Subject: GE-NEBO Organizational Changes

I wish to confirm our understanding reached in the July 22, 1982, meeting between Mr. J. Barnard, Dr. L. S. Bohl, and myself, with John Gilray of your staff and Dick Vollmer, Director, Division of Engineering. Effective August 16, 1982, the functions of the Product & Quality Assurance Operation are transferred to a new component entitled Quality Assurance and Reliability Operation (QA&RO) which reports to the Vice President and General Manager, Nuclear Engineering Division. An abridged BWR organization chart showing the key QA positions in this reorganization, labeled Figure 1-7, is attached and will replace the current Figure 1-8 (page 1-20) of the General Electric Company Topical Report NEDO-11209-04A, Revision 3.

Figure 1-7. Abridged BWR Organization Chart Showing Key QA Positions and Quality Council Members

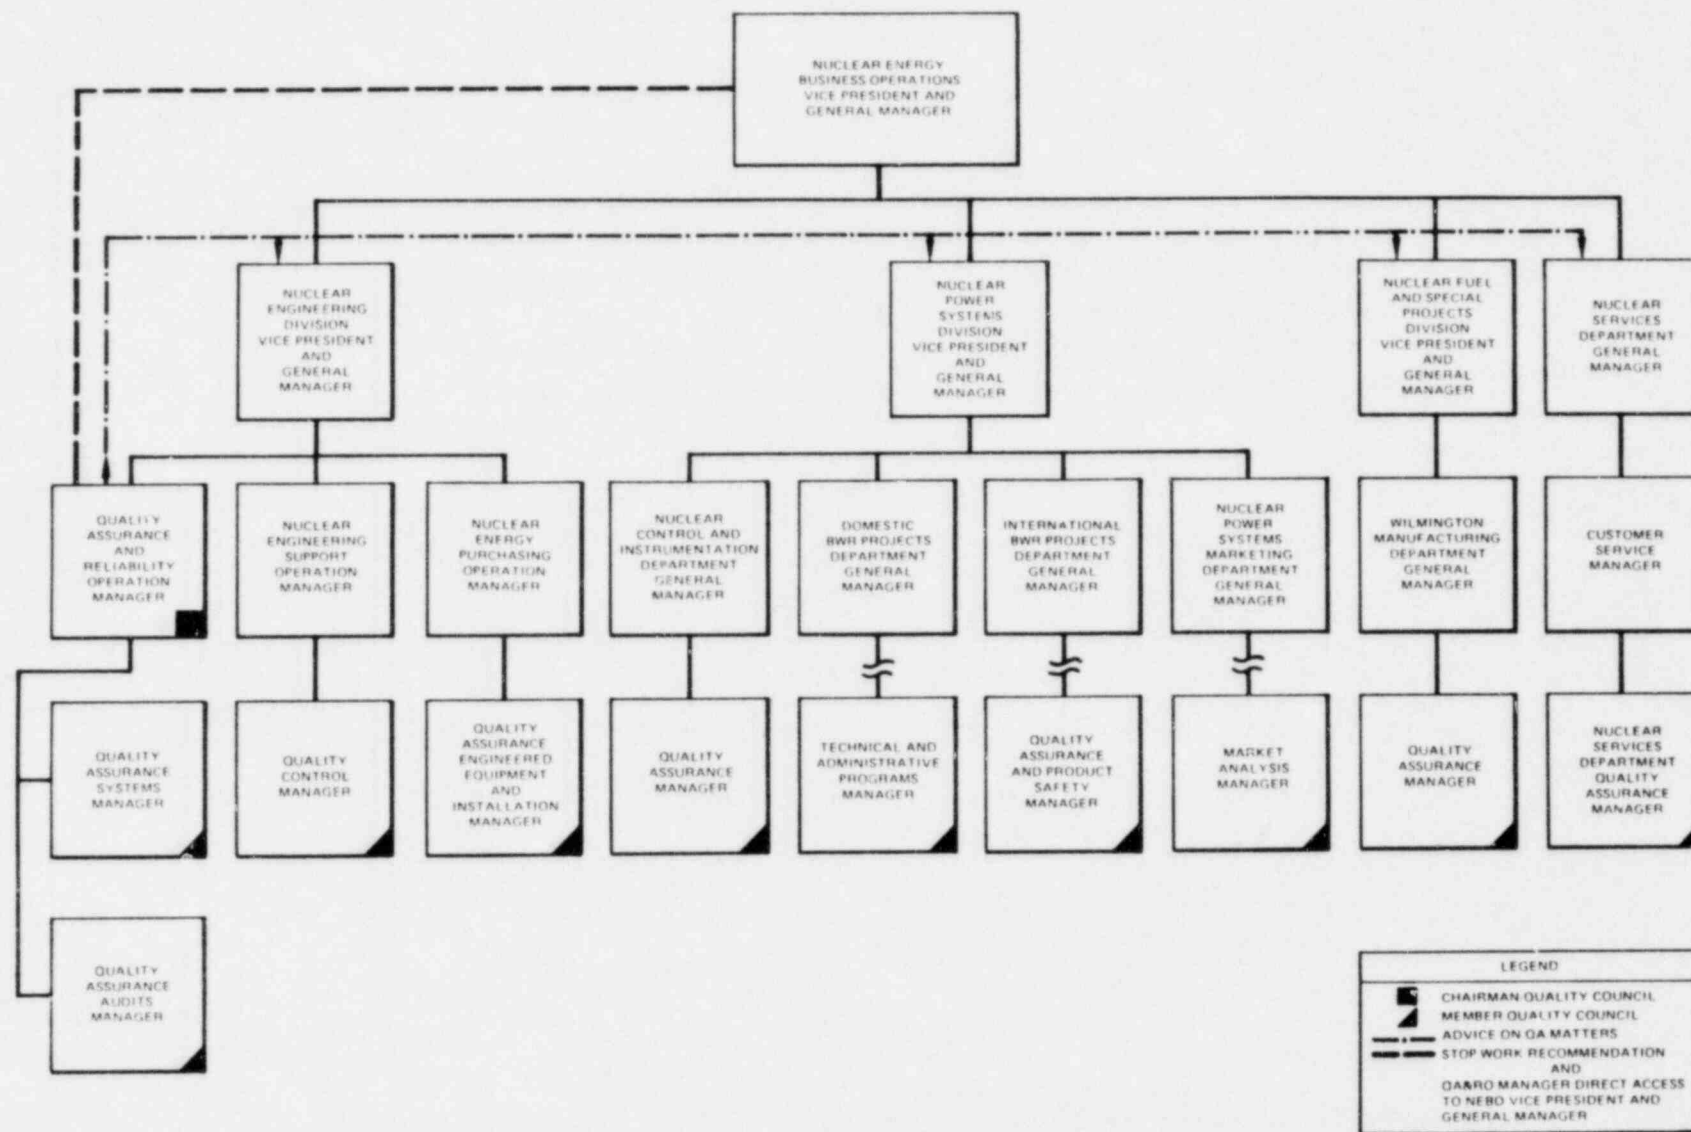
As we agreed, three points clarifying certain elements of this reorganization will be included in the next issue of topical report NEDO-11209-04A, Revision 3.

1. The top Nuclear Energy Business Operations (NEBO) quality-related policies and instructions will continue to be issued by the Vice President and General Manager, NEBO.
2. Audit reports prepared by QA&RO will be issued independently by QA&RO to the appropriate top-level NEBO management.
3. The Vice President and General Manager, Nuclear Engineering Division, has been designated by the Vice President and General Manager, Nuclear Energy Business Operations, as the quality and engineering conscience of the Nuclear Energy Business Operations. As the quality conscience of the Nuclear Energy Business Operations, the Vice President and General Manager, Nuclear Engineering Division will have the following responsibilities:
 - (a) To ensure that the intent of the NEBO quality policies are reflected in the products and services that are intended to be used in nuclear facilities.

Later this year, the Topical Report NEDO-11209-04A, Revision 3, will be revised to reflect the reorganization and the foregoing points.
